ENERGY STAR Version 7.0 Criteria Revision for Windows, Doors, and Skylights

Draft 2 Stakeholder Webinar

March 1, 2022

Draft 1 Proposed Climate Zone Changes

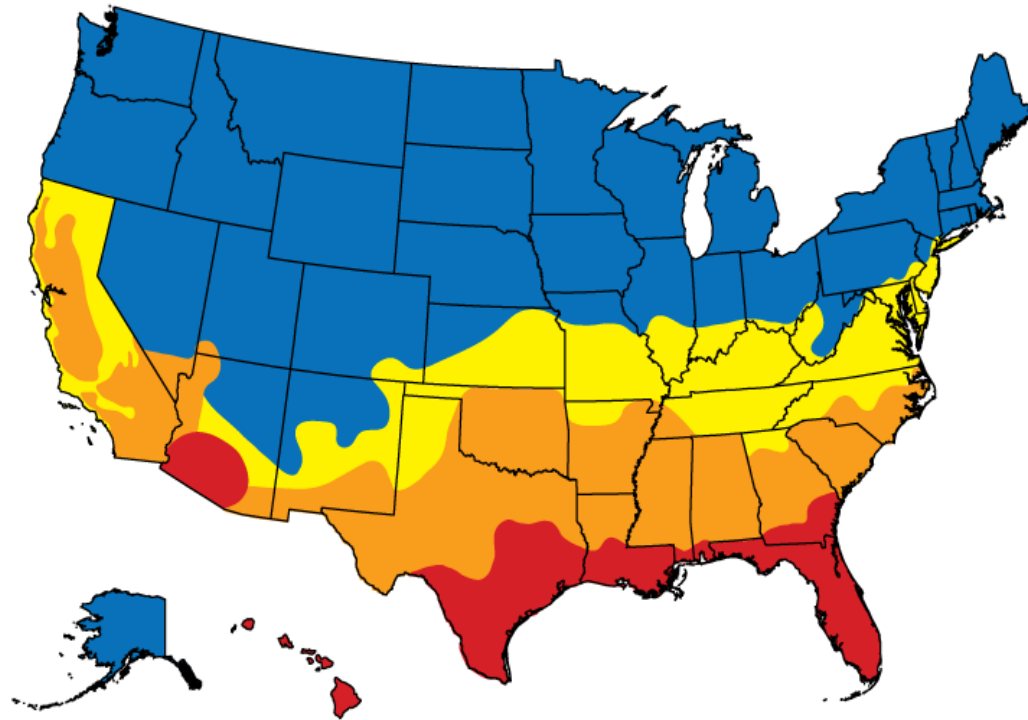
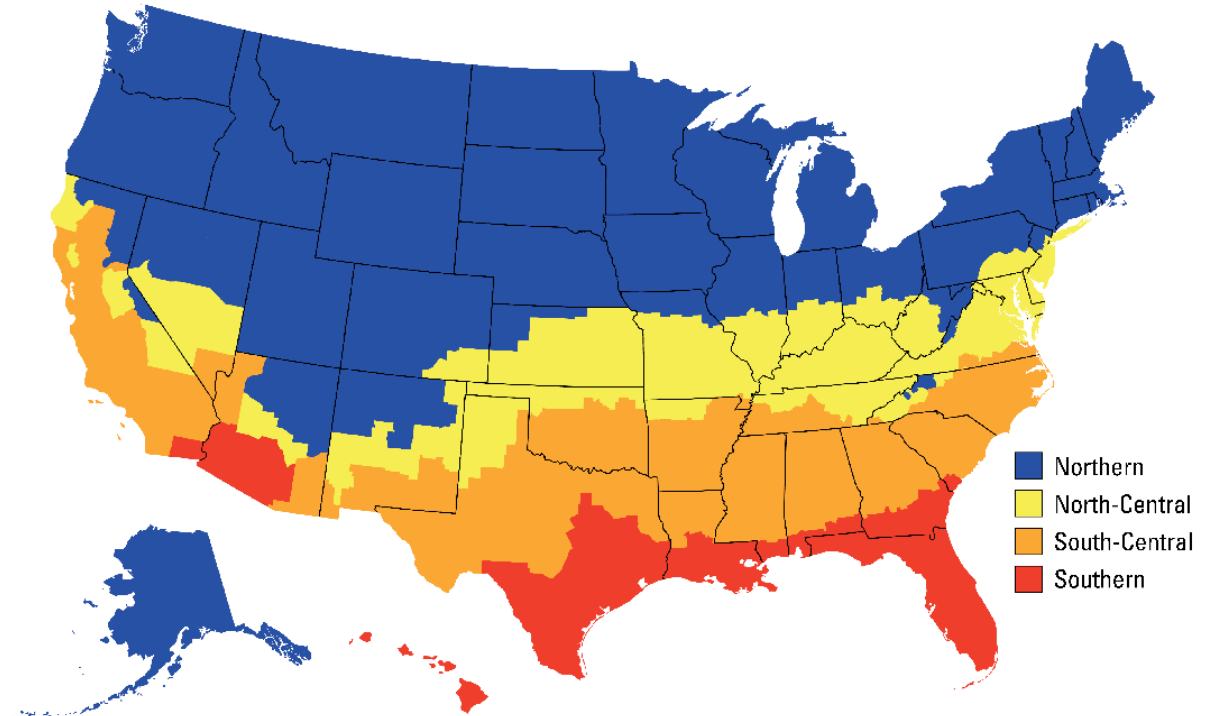
Zone changes based on IECC 2021

Minimum SHGC Analysis for Northern Zone Products

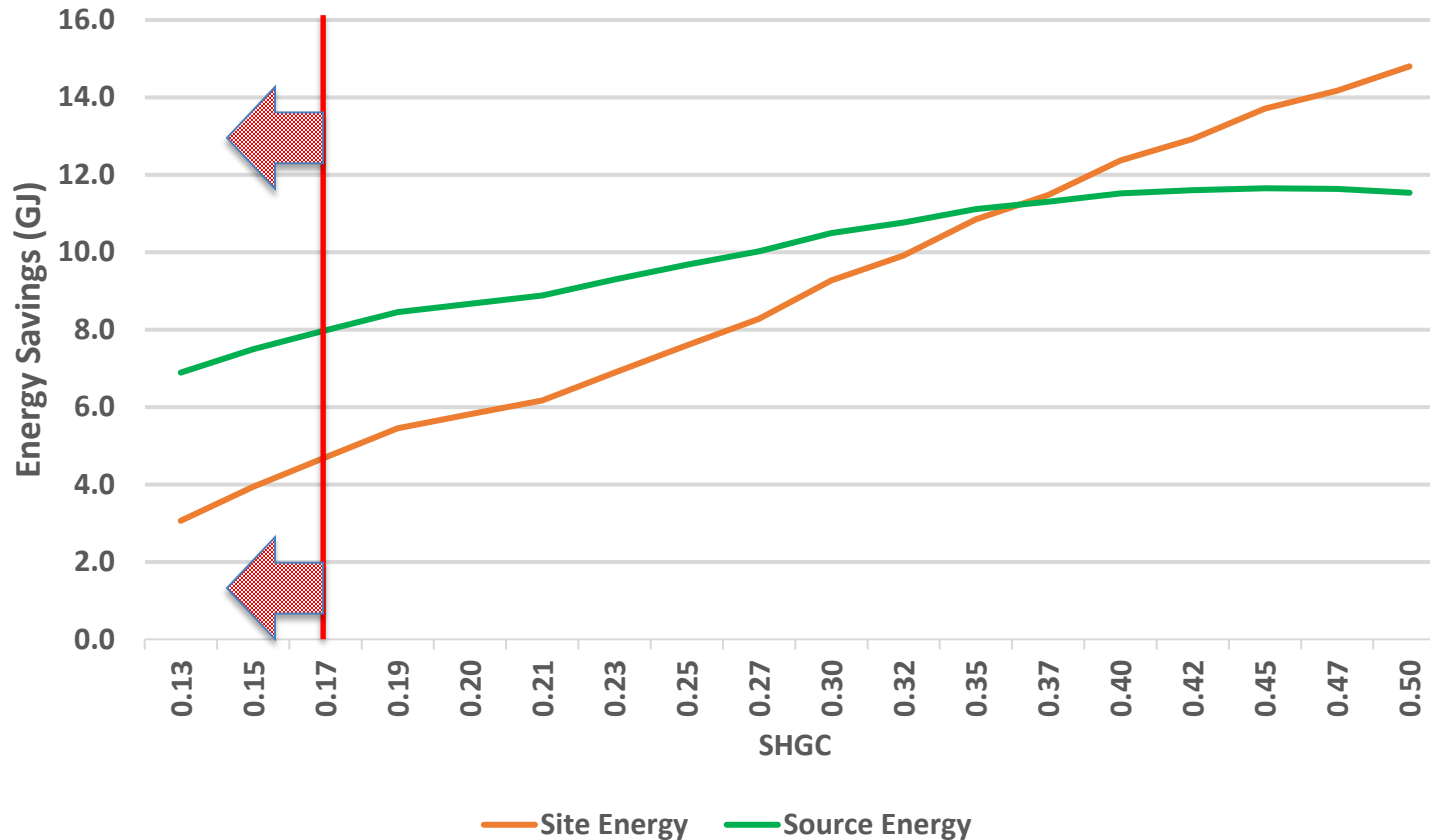
- Concern over the proposed minimum SHGC in the North
 - LBNL ran additional analysis to provide more data on this issue
 - Results show lower SHGC products in the North save less energy
 - Site vs Source energy comparison shows similar results

Lower SHGC = Lower Energy Savings

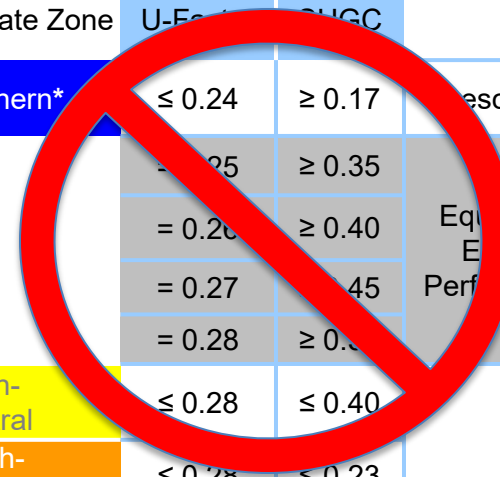
- EPA asked for feedback on applying the window criteria to full-lite sliding patio doors in the Discussion Guide and found patio doors:
 - Large area lite with a frame and are more like windows in design
 - Consumers like to match look and feel with windows
 - Patio doors use similar glass packages as windows
- Commenters pointed out that, at the Draft 1 proposed levels, ENERGY STAR sliding glass patio doors would be much more expensive and would have a much lower U-factor (better performance) than ENERGY STAR swinging full lite doors.

**Draft 2:
Propose to
move patio
doors back with
swinging doors**

Swinging Door Criteria Change

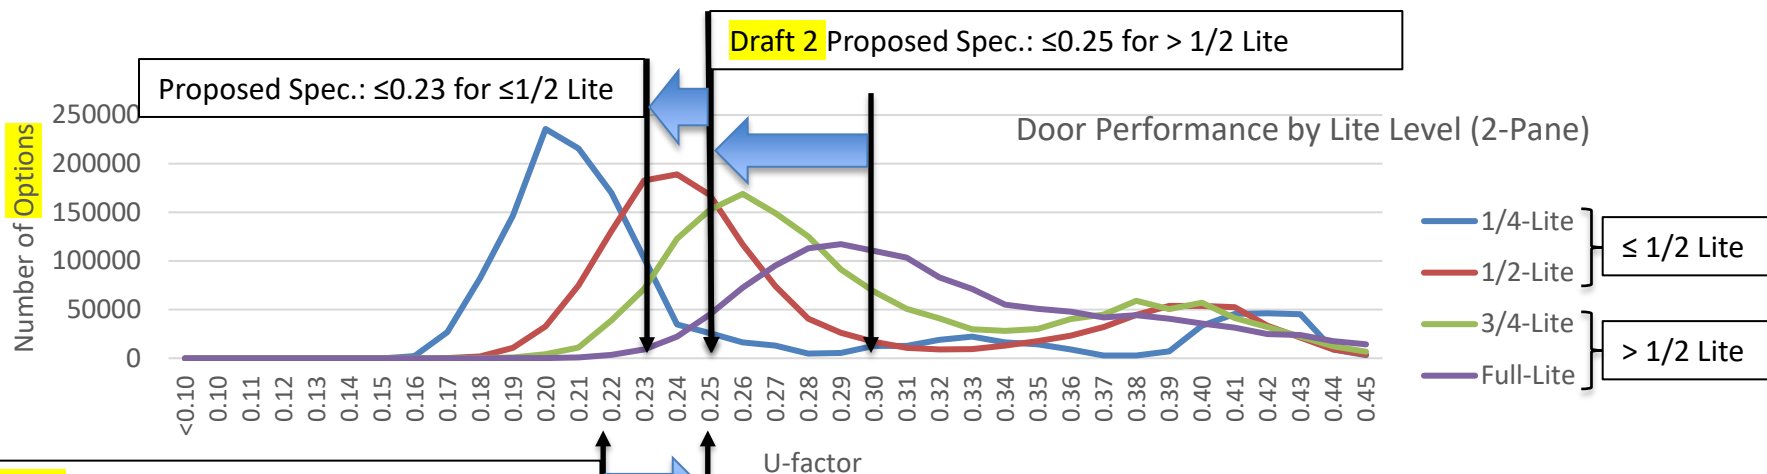
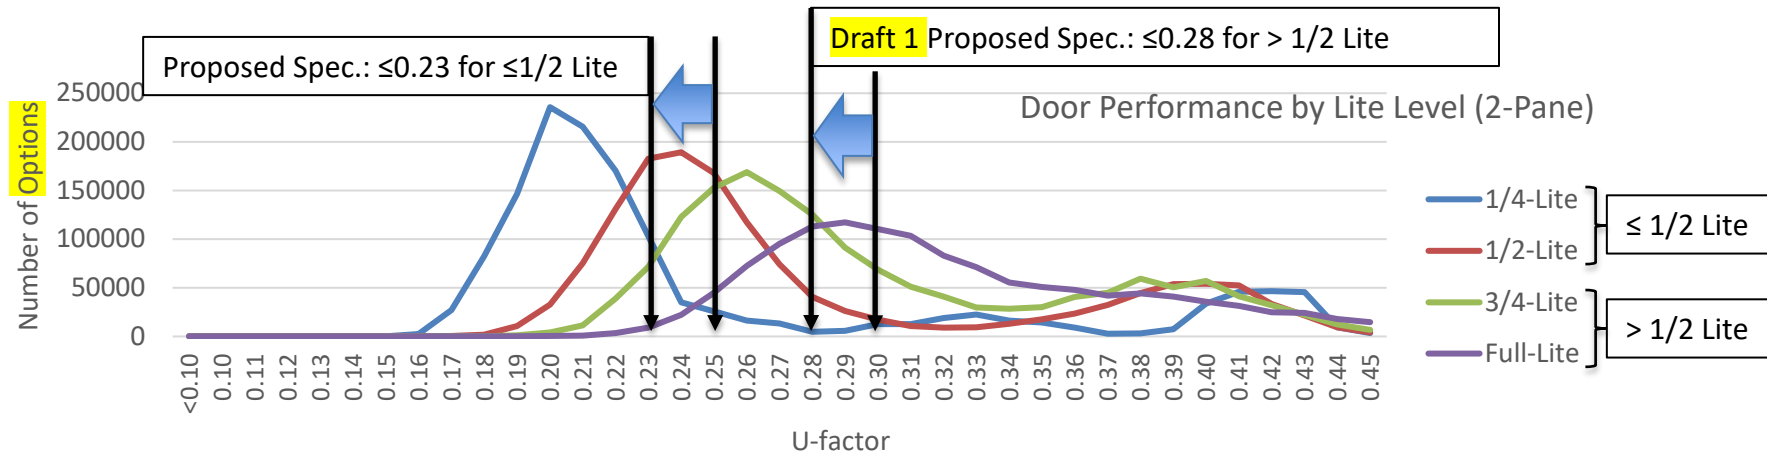
- EPA asked for stakeholder feedback on possibly sunseting the swinging door in the Discussion Guide
 - Small amount of energy savings (a smaller percentage of wall surface area)
- EPA decided not to sunset criteria in Draft 1 – found additional opportunity for improvement
 - EPA did rough energy savings analysis for doors using windows analysis and adjusting for area
- In response to Draft 1, some commenters stated they preferred that sliding glass patio doors to go back into the swinging doors category
- Therefore, in Draft 2 EPA proposes to move sliding glass patio doors back into the swinging doors criteria but with an adjustment to the criteria:
 - Move U-factor criteria for sliding glass patio doors higher (less stringent)
 - Move U-factor criteria for full-lite swinging doors lower (more stringent)
 - However, the criteria would meet in the middle as a compromise

Draft 2 Proposed Climate Zone Island Changes

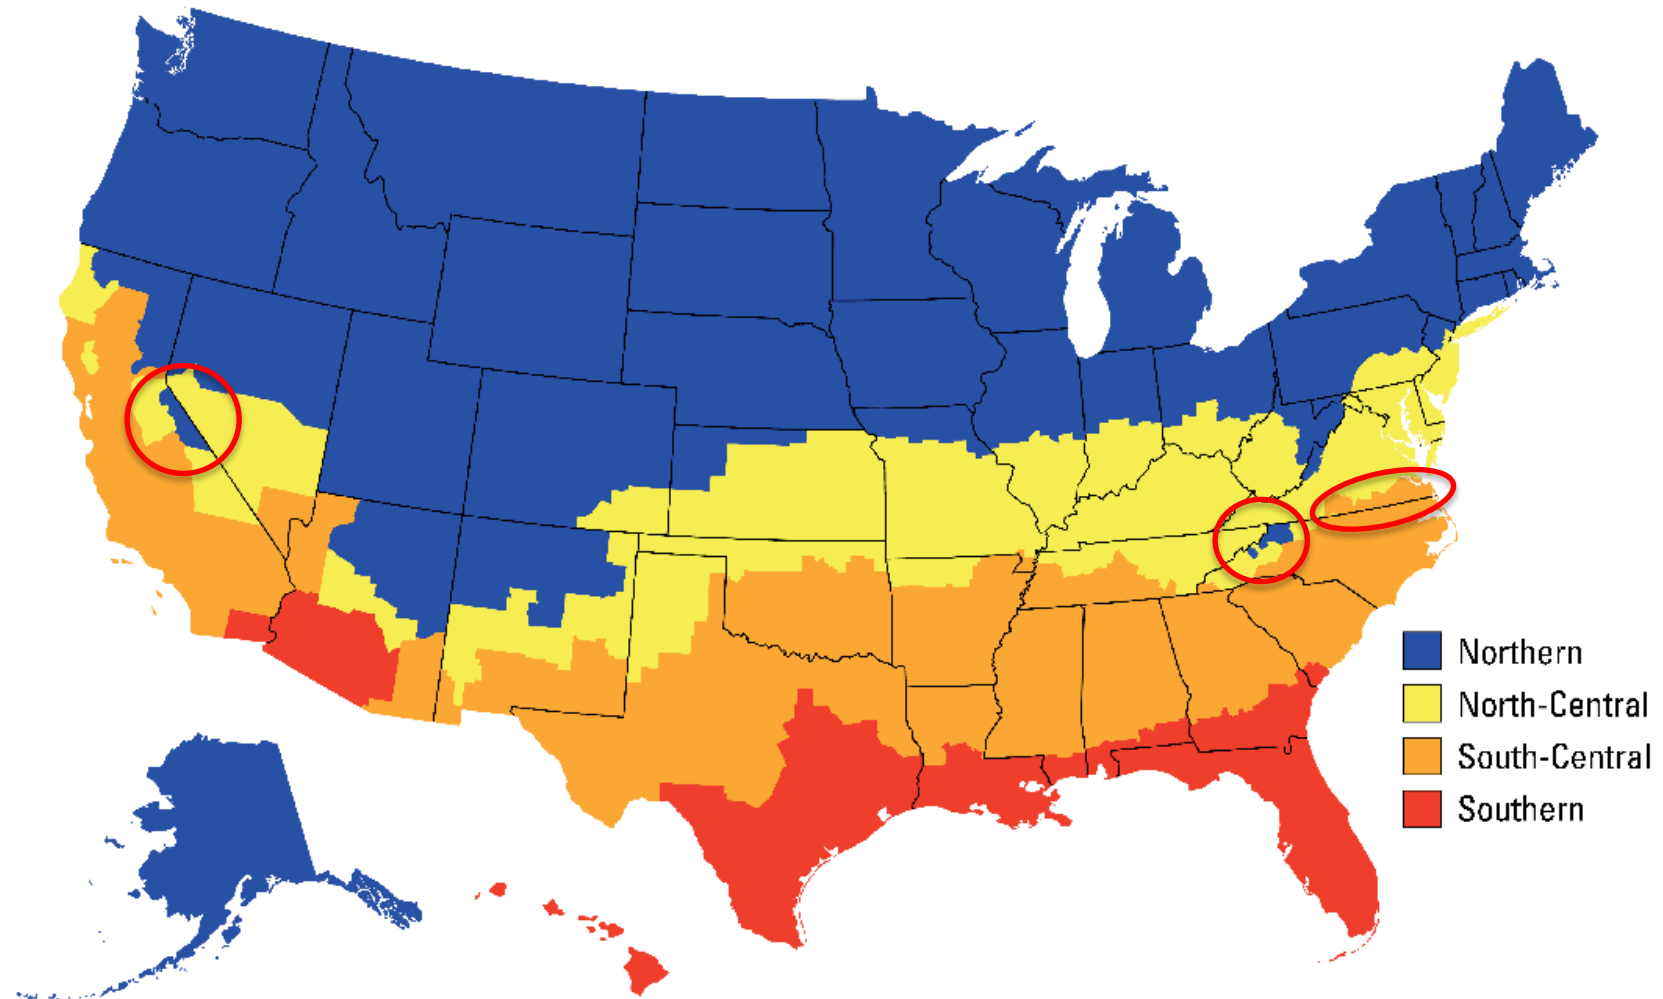
See list of 12 county changes for CA, NC, and VA in the Appendix of the Draft 1 Response to Comments
